Re: Application of Bluegrass Wireless LLC for issuance of a Certificate of Public Convenience and Necessity to Construct a Cell Site (BURNSIDE) in Rural Service Area #6 (PULASKI) of the Commonwealth of Kentucky, Case No. 2005-00282

Geotechnical Engineering Report - Addendum Proposed Burnside II Communication Tower Lake Cumberland Motor Speedway Burnside, Kentucky Terracon Project No. 57057351G

DRILLED PIER FOUNDATION DESIGN

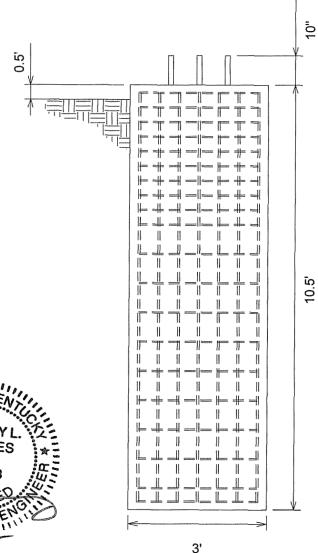
Soil values obtained from Terracon soils report #57057351G Addendum 1 Dated 11/18/05

Vertical Bars	(12) #8 bars, 10' long
Ties	#5 bars @ 6" c/c for the first 6.5' then 16" c/c thereafter
